Technical Notice

Product Name: AFL3-W07A-BT Series	Implementation Date: October 20, 2015 Status: Running Change
--	---

This notice is to inform you of changes to the AFL3-W07A-BT series.

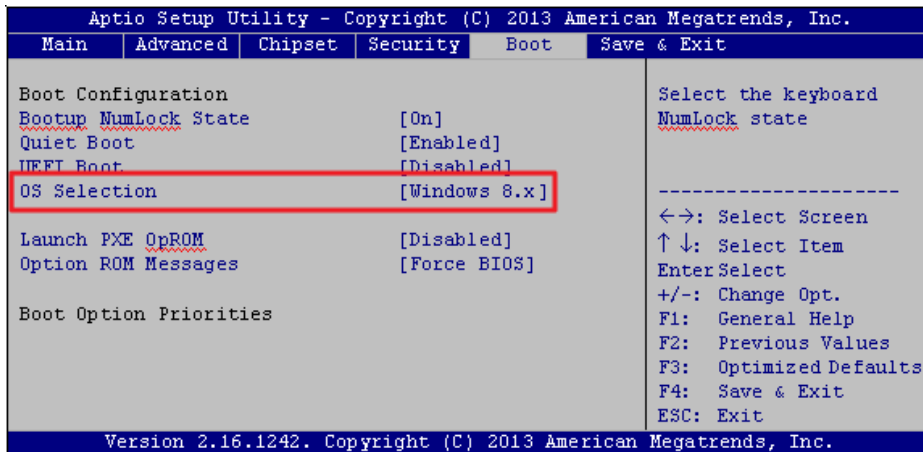
Phase-out of the touchscreen controller, and to solve the compatibility issue between motherboard USB 3.0 interface and replacement touchscreen controller USB 2.0 interface, the BIOS is upgraded and the installation procedure of operation system is changed as well. All the changes will be implemented from product serial no. **SA15939212**.

Before installing the operating system, enter the **Boot** BIOS menu and choose which operating system you will be installing.

Previous P/N	Replacement P/N
Touch Screen	75200-02007009VT-RS	75200-02007013TX-RS
Touch Controller	EETI EXC7200	Goodix GT9113
Multi-touch	2-point	10-point
BIOS	H787AM11	H787AM13
